ADDENDUM TO CLASS 1  
PIPING STRESS REPORT

COMMONWEALTH EDISON COMPANY  
LASALLE UNIT 2  
PROJECT NO. 4267-00

SYSTEM: MAIN STEAM PIPING  
SUBSYSTEM: 2MS-31B REV. 02  
EMD- 042129 ISSUED ON: 03-24-83

ADDENDUM: C  
ISSUED ON: 06-08-93

The following shows the valve c.g. orientation before and after rotating the motor operator by 90°:

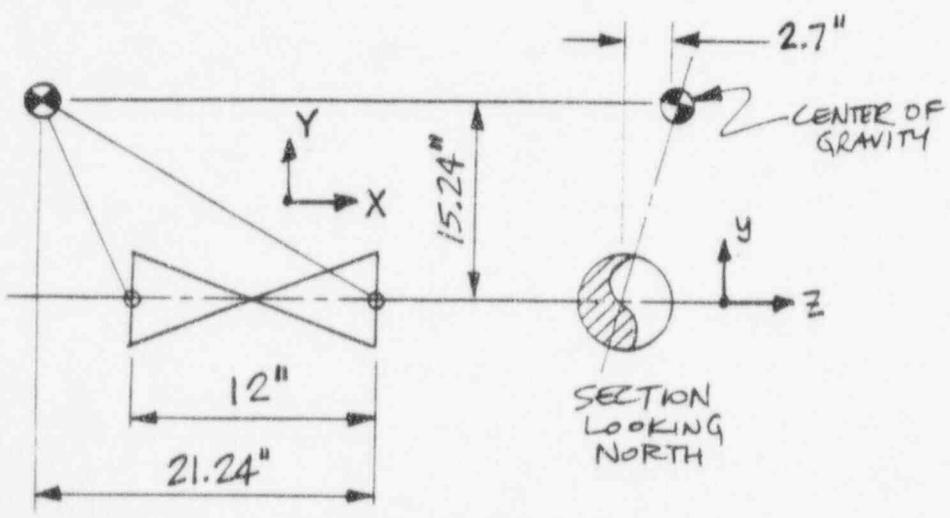
**PURPOSE:** The purpose of this calculation is to compare the design position of the valve 2B21-F020 center of gravity to the proposed position with the motor operator rotated 90°. This calculation will show that the differences are minor and that there is no need for seismic or weight reanalysis.

**ASSUMPTIONS:** The weight of the valve + Motor operator remains the same, only the position of the valve-motor operator center of gravity changes.

VALVE ORIENTATION BEFORE ROTATION OF MOTOR OPERATOR  
SEE REFERENCE 1

VALVE ORIENTATION AFTER ROTATING VALVE OPERATOR BY 90°  
SEE REFERENCE 2

**CONCLUSION:** The changes in the coordinates of the valve-motor C.G. are minor (max  $\Delta = 3.93"$ ) and will not significantly affect the weight and/or seismic analyses. The proposed 90° rotation of the valve 2B21-F020 motor operator is acceptable.

∴ MAX Δ = 3.93'', NO SIGNIFICANT CHANGE IN SEISMIC RESPONSE AND/OR WEIGHT LOADING.
